BULLETIN

B-0011

TANK "JITTER" PROBLEM, MONITOR MODIFICATION

Figure 1

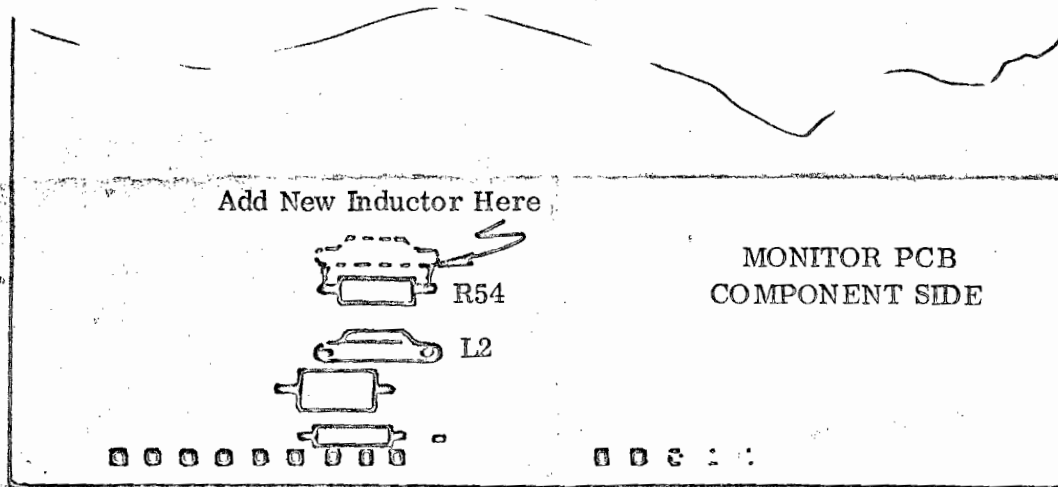
The problem of jitter in the upper portion of the display, particularly evident in TANK II, has been carefully evaluated by the Atari Engineering Department. The most practical answer has been found to be a minor modification to the monitor printed circuit board, involving the addition of a small inductor. The necessary component (inductor) is being supplied by Atari to purchasers of the Tank games, without charge, and should be installed into the monitor printed circuit board as described below.

1. Looking at the top (component side) of the monitor printed circuit board, (see Figure 1), near the rear edge and left of center, locate the two components, inductor L2 and a 39 ohm resistor R54. These components are installed in parallel.
2. The modification consists of adding an inductor (supplied with this bulletin) in parallel to the existing components, L2 and R54. For greatest convenience, therefore, it is only necessary to solder the new inductor directly across R54 on the component side of the circuit board.
